UNITED STATES PATENT AND TRADEMARK OFFICE

APPLICATION NO.	FILING DATE	FIRST NAMED INVENTOR	ATTORNEY DOCKET NO.	CONFIRMATION NO.
10/728,191	12/04/2003	Jitendra Mohan	P05747 (NATI15-05747)	7313
23990	7590	11/21/2005	EXAMINER	
DOCKET CLERK				DANG, KHANH
P.O. DRAWER 800889				PAPER NUMBER
DALLAS, TX 75380				2111

Office Action Summary	Application No.	Applicant(s)	
	10/728,191	MOHAN, JITENDRA	
	Examiner	Art Unit	
	Khanh Dang	2111

DETAILED ACTION

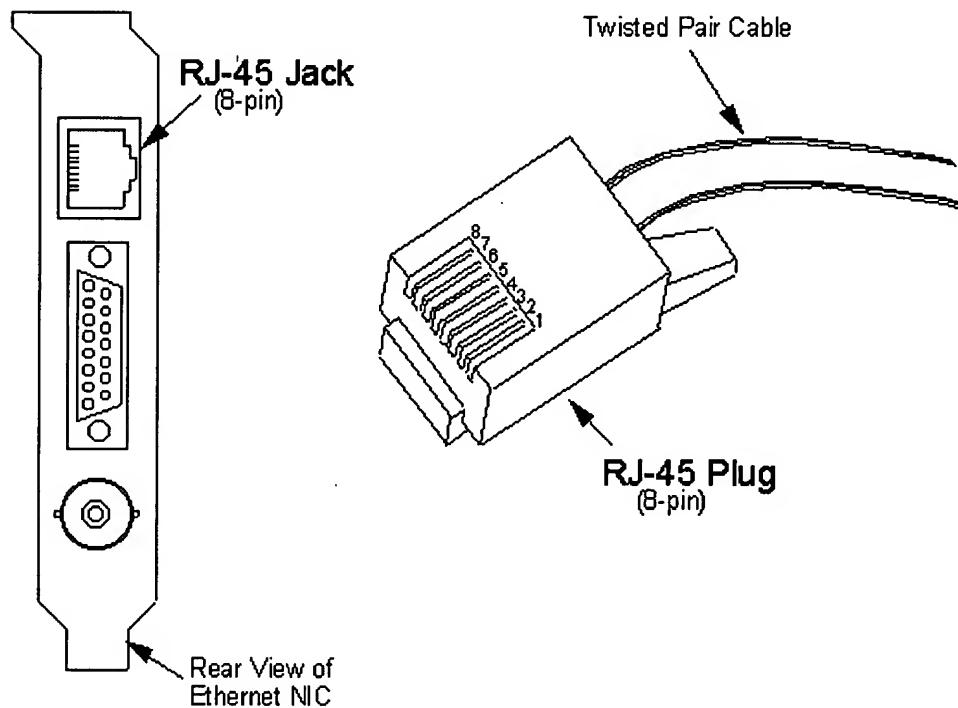
With regard to claim 5, it is clear that in Sultenfuss, the first and second network transmission medium interfaces are RJ-45 connectors, since in Ethernet, connections are made using twisted pair CAT-5 cable and RJ-45 connectors.

RJ-45 Connectors
